## PRODUCT UPDATE: 8240P SERIES

(The 6240P Series has been discontinued and the 8240P Series has been re-designed to incorporate this option)

### WIRING DIAGRAM

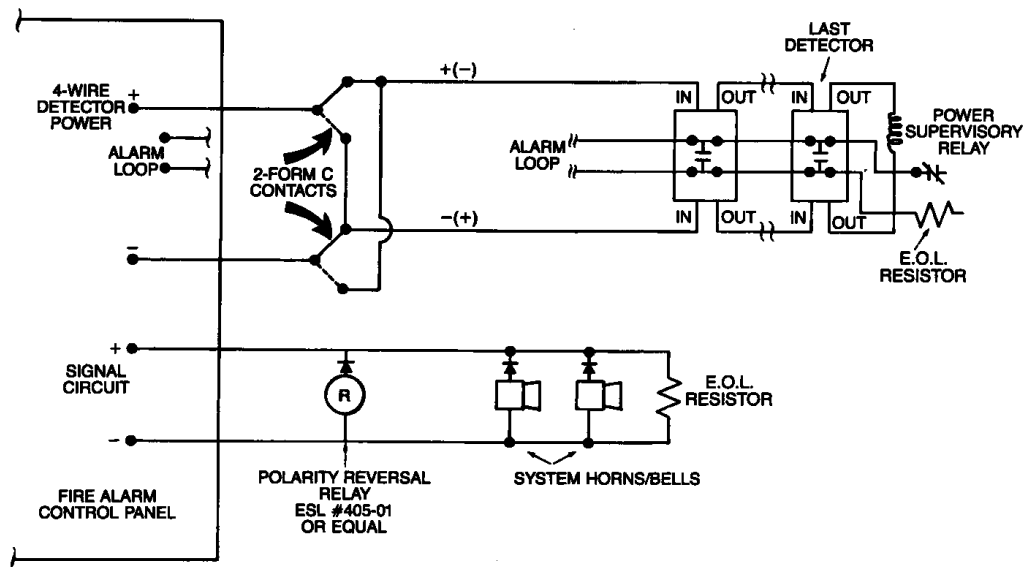
The 8240P(Y) & 8240PH(Y) are 4-wire detectors equipped with integral piezo-electric signals. These internal signals are activated upon detection of smoke at the detector of alarm or upon reversal of polarity of the detector power. This application enables the integral piezo to operate either as a local evacuation signal or as a system signalling device.

The most likely application would be an 8240PY or 8240PHY. The detector would be used as a local smoke detector with the alarm contacts **not** connected to the alarm loop of the control panel. In this manner, upon detection of smoke, the piezo would sound at the detector of alarm and restore to normal after smoke clears. If equipped with the isolated thermal (H option), the thermal contact would be connected to the alarm loop. If any device connected to the alarm loop is activated the alarm panel is put into an alarm condition which activates the polarity reversal relay which activates the piezo signals in all connected 8240PY/8240PHY smoke detectors. The piezo would continue to sound until the panel is reset or until the alarm/signal silence is manually operated at the panel.

- 1) When energized by reverse polarity only the piezo signal is activated within the detector. The auxiliary and alarm contacts and alarm LED are not energized unless the unit detects smoke.

- 2) While operating in reverse polarity mode, the detector may still detect smoke and operate, thus activating all relays and LED.
- 3) The polarity reversal relay should be connected to the signal circuit of the panel so that the signals will silence upon operation of the Alarm Silence button at the fire alarm control panel.

- 4) The contacts of the reversal polarity relay must be of adequate rating to carry the current load of all connected integral detector signals.
- 5) The reverse polarity relay must be polarized with a blocking mode to provide for supervision of the signal circuit.

- 6) The power supply of the fire alarm control panel must be sized to provide for simultaneous and continuous operation of all integral piezo signals.

- 7) If latching detectors are used, it will be necessary to operate the 4-wire detector reset at the fire alarm control panel to reset any detectors in actual alarm condition.
